STRATEGY TO ADVANCE FLOOD PROTECTION, ECOSYSTEMS AND RECREATION ALONG SAN FRANCISCO (SAFER) BAY

CEQA Scoping Report

Prepared for
San Francisquito Creek Joint Powers
Authority

October 2022

Figure 1
Project Location and Components

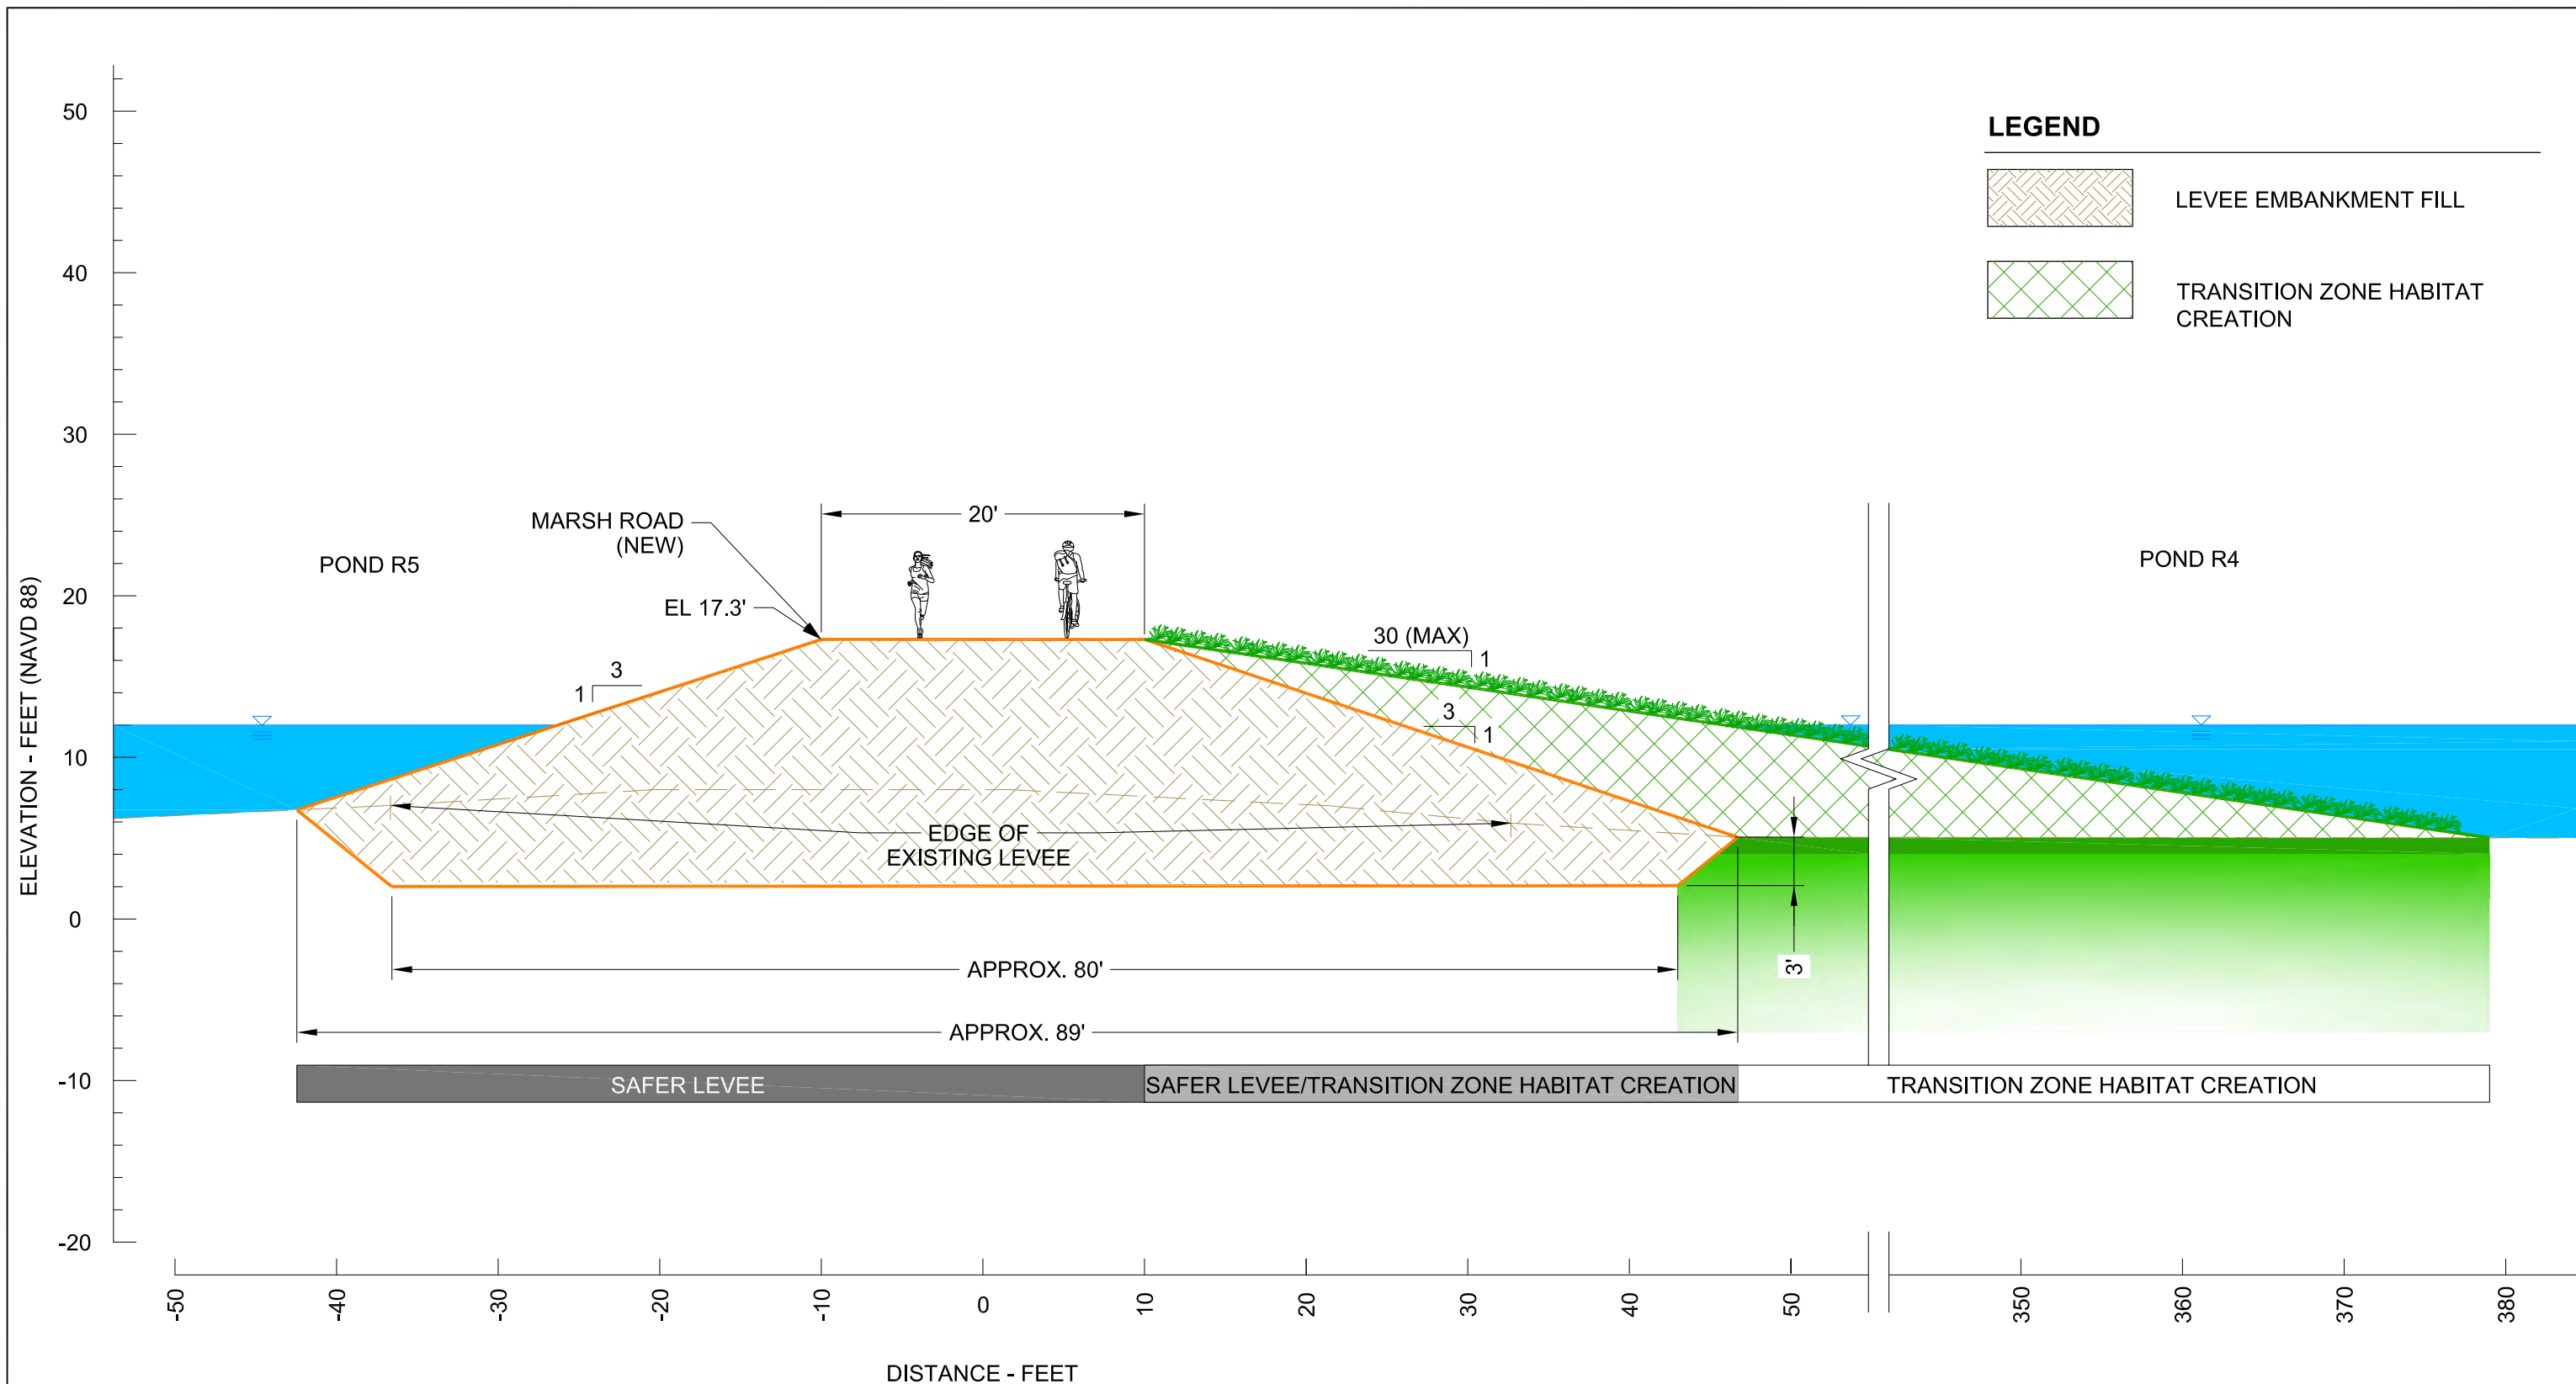
<p>9. Figure I in the NOP as well as the discussion in the text and in the scoping meeting consistently describe Ravenswood Ponds R1 and R2 as being restored to tidal marsh. That is certainly a possibility, but it is only one of the possible futures for these two ponds under the SBSPRP's multi-phase implementation plan and the guiding documents and programmatic permits for our project. Under our Adaptive Management Plan, we have to weigh the needs of a range of different endangered, threatened, and other special-status species as each phase of the project is implemented and strike a balance between tidal marsh restoration and various types of managed pond enhancements that will bring benefits and impacts to these different species. We have not yet reached a point where we can evaluate what to do with Ponds R1 and R2. They may indeed be restored to tidal marsh, but they may instead be retained and enhanced as ponds for other species. We strongly encourage the SAFER Bay Project team to include every combination of these different habitat outcomes for these ponds in the EIR, so that the alternative selected and advanced is consistent with the decisions and needs of the SBSPRP and the Refuge.</p>	<p>As indicated in the NOP, "The restoration scenarios include tidal marsh or a combination of tidal marsh and managed ponds." The SFCJPA will continue to work with the SBSPRP and Refuge regarding restoration scenarios within Ponds R1 and R2. The SFCJPA understands that SAFER Bay's Project Description will need to retain flexibility for the types of habitat targets of future restoration/management in Ponds R1 and R2.</p>

<p>10. Figure I includes a habitat transition zone in Pond R2. We are not necessarily opposed to including this feature at this location, but it may not be necessary or desirable if that pond is kept as a managed pond. And even in the tidal marsh restoration scenario, it may not provide much additional habitat value in that location. We encourage you to consider alternatives both with and without that feature.</p>	<p>The SFCJPA agrees that a habitat transition zone may not be constructed or located as shown in Figure 1, but at another mutually agreeable location(s) that optimizes ecological lift. The SFCJPA will continue to work with the SBSPRP and Refuge on optimum combinations of restored and/or enhanced target habitats and associated transition zone habitats in Ponds R1 and R2. The SAFER Bay Project team's habitat restoration ecologists/hydrologists will collaborate with the SBSPRP and Refuge to develop conceptual options for various restored high tide refugia features, in addition to horizontal levee type T-zones (e.g., intermarsh islands/mounds, elevated berms along historic slough channels).</p>

<p>22. Figure 1 suggests three possible levee alignments in SF2. It is of significance that these Refuge lands are required under Refuge priorities and the National Wildlife Refuge System Administrative Act⁸ to dedicate the highest priority to wildlife and the habitat they require. Any levee crossing, new or increased in size can cause extensive temporary and permanent impact on the wildlife that require this habitat, multiplied by the number of levee alignments built. The greatest impact would occur for levees bisecting and disrupting habitat such as the alignment shown near the Bay or that of the existing berm separating the migratory bird island pond and snowy plover habitat. For these reasons we recommend that the EIR consider a University Avenue levee only.</p>	<p>A levee alignment along University Avenue will be considered for inclusion in the DEIR. Please refer to the global response on Project Development and Alternatives Screening.</p>

5. Figure 1 in the NOP as well as the discussion in the text and in the scoping meeting consistently describe Ravenswood Ponds R1 and R2 as being restored to tidal marsh. That is certainly a possibility, but it is only one of the possible futures for these two ponds under the SBSPRP's multi-phase implementation plan and the guiding documents and programmatic permits for our project. Under our Adaptive Management Plan, we have to weigh the needs of a range of different endangered, threatened, and other special-status species as each phase of the project is implemented and strike a balance between tidal marsh restoration and various types of managed pond enhancements that will bring benefits and impacts to these different species. We have not yet reached a point where we can evaluate what to do with Ponds R1 and R2. They may indeed be restored to tidal marsh, but they may instead be retained and enhanced as ponds for other species. We strongly encourage the SAFER Bay Project team to include every combination of these different habitat outcomes for these ponds in the EIR, so that the alternative selected and advanced is consistent with the decisions and needs of the SBSPRP and the Refuge.

6. Figure 1 includes a habitat transition zone in Pond R2. We are not necessarily opposed to including this feature at this location, but it may not be necessary or desirable if that pond is kept as a managed pond. And even in the tidal marsh restoration scenario, it may not provide much additional habitat value in that location. We encourage you to consider alternatives both with and without that feature.

Figure 1 of the NOP shows seven cross-section locations on an aerial figure of the Project site but does not label them in accordance with the figure numbers of the

1. Please identify the SFPUC's Ravenswood site in Figure 1
2. The project boundaries are unclear; please revise the project site map.
3. The location of proposed project improvements, such as levees, is unclear. Please revise the project site map so that we can understand exactly what improvements and/or alterations are proposed on SFPUC property and how they might affect SFPUC infrastructure and operations..

The NOP’s Project Location and Components map (Figure 1), suggests levee locations along Bayfront Expressway at its bridge approach and also three connections bisecting or adjoining the Refuge’s Pond SF2. Even though this part of the Project is program-level, it is a concern that the map’s suggestions omit mention of various options developed in the 2020 Dumbarton

- Figure 1 suggests three **possible levee alignments in SF2**. It is of significance that these Refuge lands are required under Refuge priorities and the National Wildlife Refuge System Administrative Act⁸ to dedicate the highest priority to wildlife and the habitat they require. Any levee crossing, new or increased in size can cause extensive temporary and permanent impact on the wildlife that require this habitat, multiplied by the number of levee alignments built. The greatest impact would occur for levees bisecting and disrupting habitat such as the alignment shown near the Bay or that of the existing berm separating the migratory bird island pond and snowy plover habitat. For these reasons **we recommend that the EIR consider a University Avenue levee only**.

Figure 3 from the NOP shows a levee with an 84-foot base extending from the edge of Hacker Way west into Ravenswood Slough.

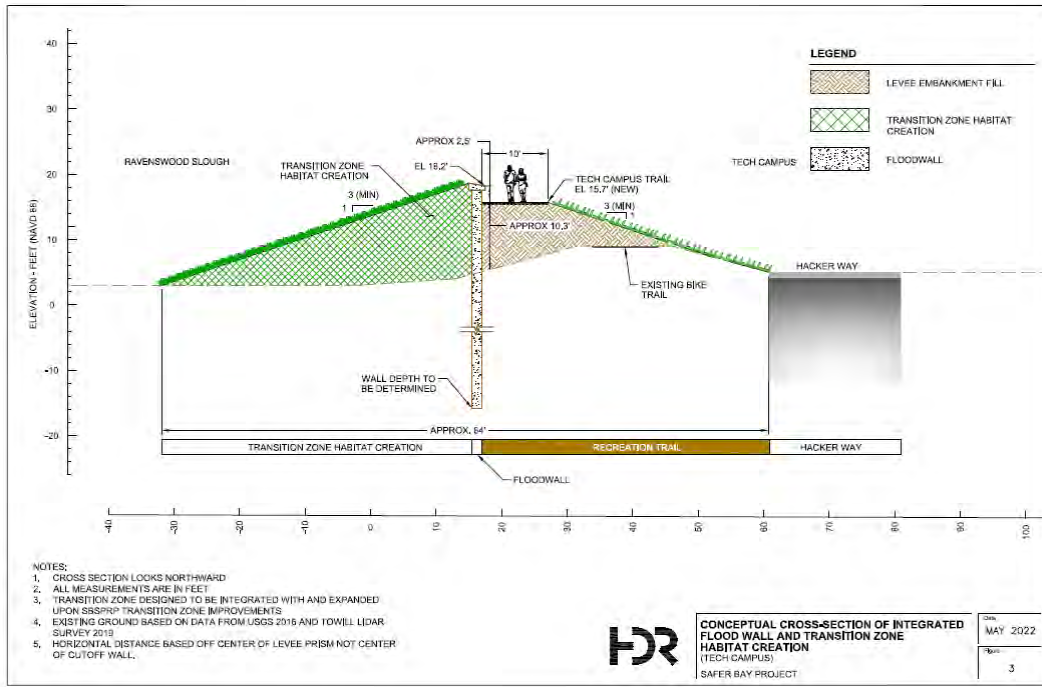
The NOP does not provide information on potential Project impacts to the salt marsh habitat in this section of Ravenswood Slough; however, using the figures provided in the NOP (Figures 1,3 and 4) it is clear that there is a potential for loss of salt marsh along 1.25 miles of Ravenswood Slough from the proposed Project levee.

- ★ For each alternative considered in the EIR for this reach, even at the program level, there must be specific locations and acreage provided for any wetlands and waters that could be temporarily, permanently, directly and indirectly impacted from the Project. The types of impacts and acreages of impacts should be provided in a table – (e.g. temporary, permanent, direct, indirect, habitat type, acreage).

Exhibit 5: Typical Cross-Section, EPA South of Bay Road (SFCJPA diagram)

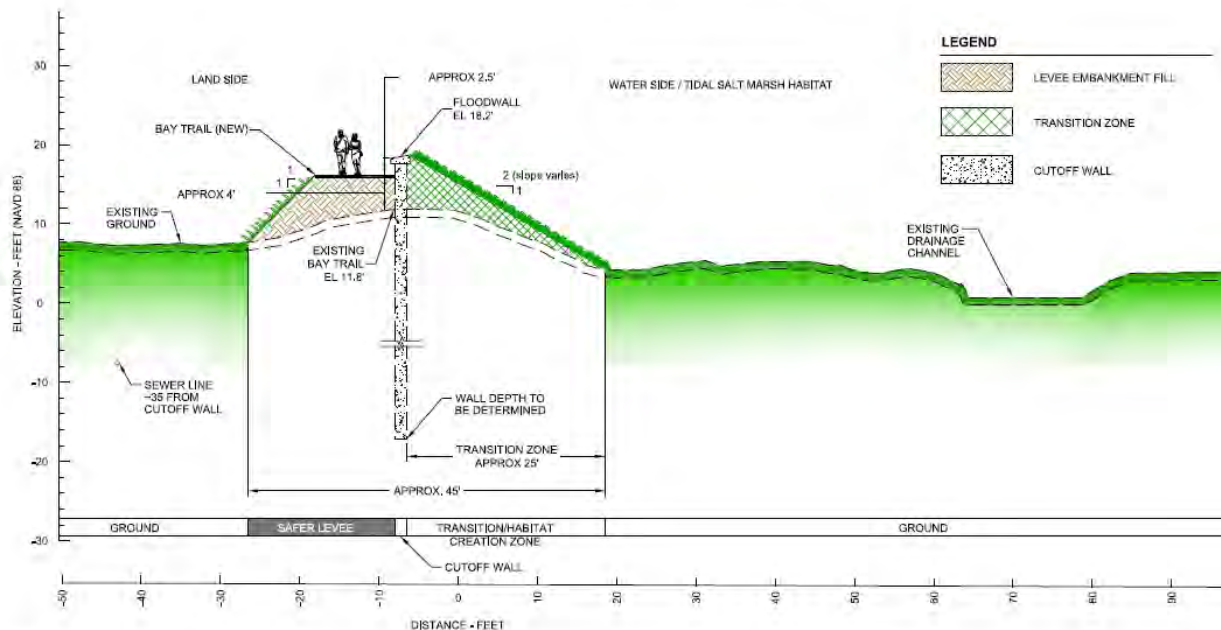
Further, based on the SFCJPA’s prior conceptual Cross-Section provided to Harvest, our design and engineering team had always assumed that a 2:1 slope would be designed and constructed along our property’s waterfront. Please see *Exhibit 5: Typical Cross-Section, EPA South of Bay Road* for this diagram provided by the SFCJPA. We submitted our Pre-Application in February 2020 and our Major Application in October 2021 to the City of East Palo Alto based on this conceptual Cross-Section provided to us by the SFCJPA and earlier conversations with SFCJPA staff members.

Exhibit 6 : Conceptual Cross-Sections of Integrated Floodwall and Transition Zone, Habitat Creation
NOP Figure 8: South of Bay Road, East Palo Alto

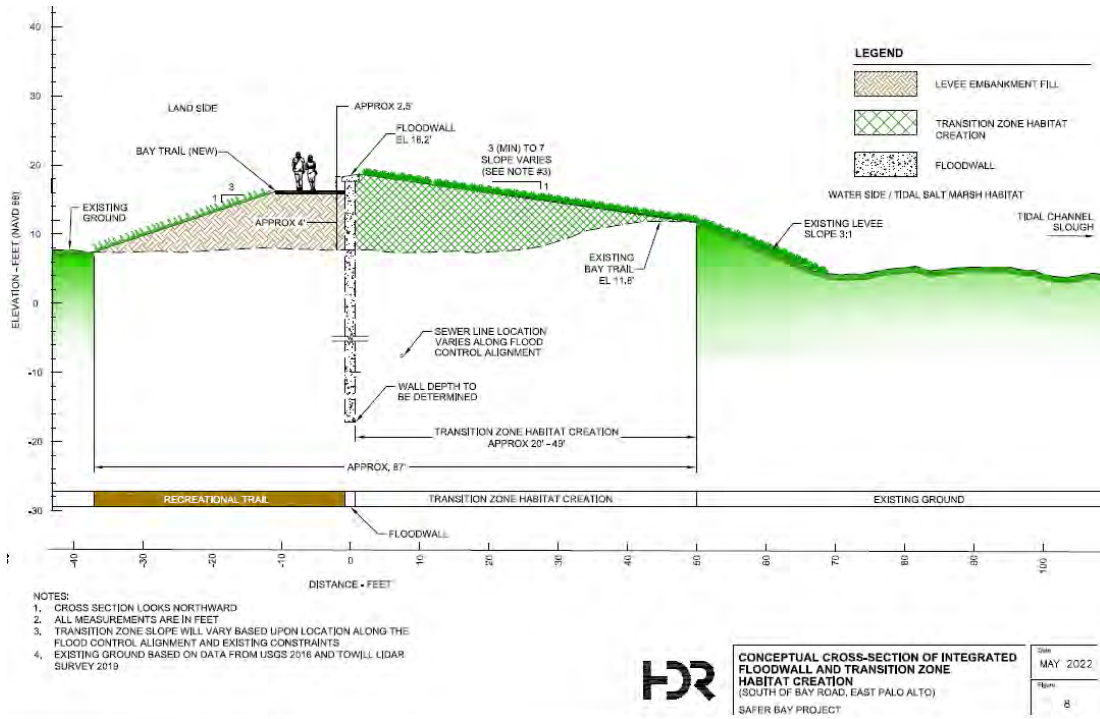
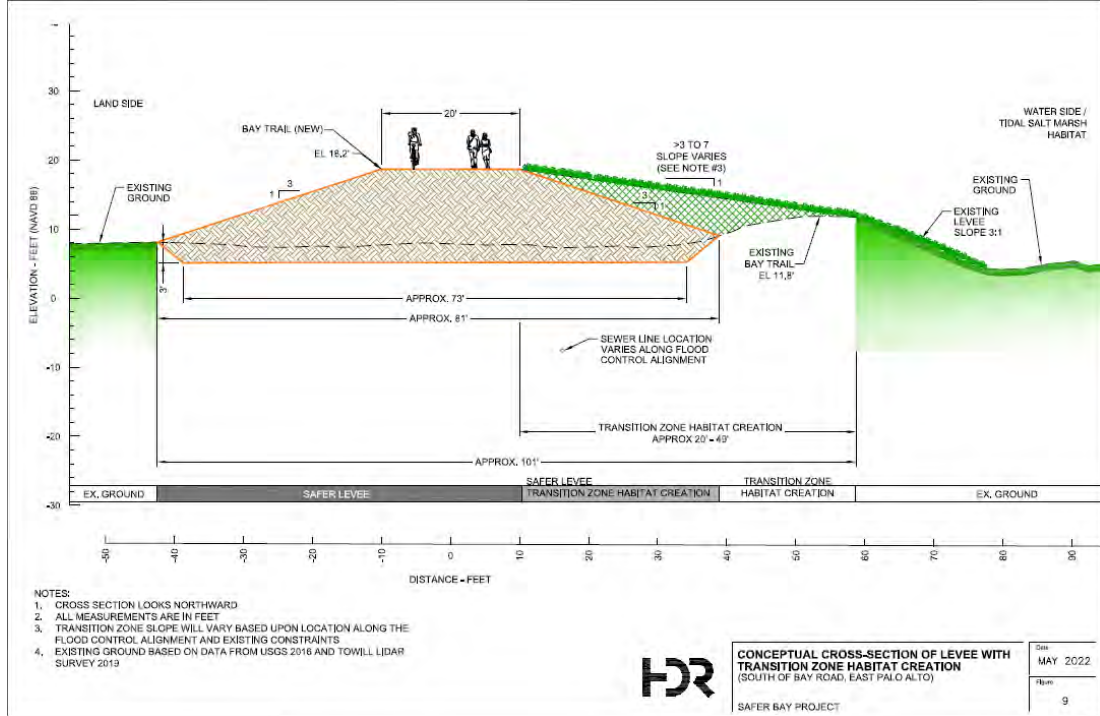
The NOP presents two (2) “Conceptual Cross-Sections of Integrated Floodwall and Transition Zone, Habitat Creation,” for the area south of Bay Road (*Exhibit 6: Figure 8 & Figure 9*). The Cross-Sections depicted are in the same location of The Landing project, as our properties extend south of Bay Road to south of Weeks Street. A slope of 3:1 (min) to 7:1 Transition Zone Habitat Creation is presented in these Cross-Sections, with a reference to Note 3 on the same page, which states: “Transition Zone will vary based upon location along the Flood Control Alignment and Existing Constraints.”

While we can appreciate the goal of maximizing this Transition Zone, it is critical to note that for portions of our site, anything greater than a 3:1 slope (and in some locations 2:1 slope) would eliminate the recreational and open space amenities that the community has expressed as critical for EPA’s waterfront. Please see *Exhibit 7: Levee with 7:1: Transition Zone*. As can be seen in this diagram, a 7:1 slope would extend inland into our property, by nearly 50 feet. If a transition zone of 7:1 were constructed along our property’s frontage, this would eliminate the possibility of the construction of the community’s children’s playground, ½ court basketball court, fitness area, picnic benches, BBQ areas, outdoor seating and the viability of future retail along that frontage. There would simply not be adequate room to construct these amenities. Additionally, the emergency vehicle access road that curves down from the end of the Weeks Street cul-de-sac would also would not be able to be constructed, which would create severe fire and emergency vehicle access problems. Others of The Landing’s amenities would also be drastically reduced in size, such as the project’s public plazas, and grassy amphitheater lawns, and waterfront seating areas.

Exhibit 7: Levee with 7:1: Transition Zone

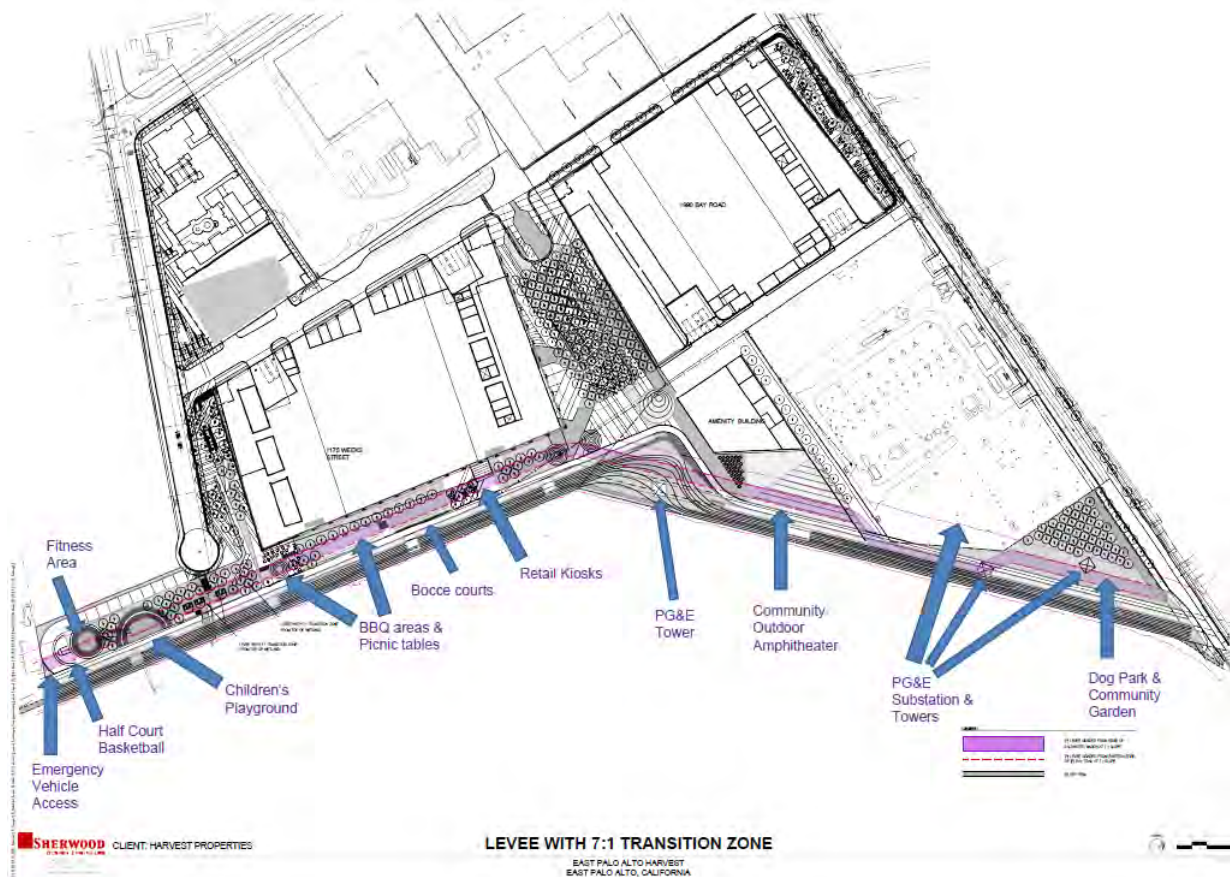
Note that the purple band in the Exhibit above represents the location of a 7:1 levee (including the Bay Trail), and, how far this would infringe into Harvest’s property.
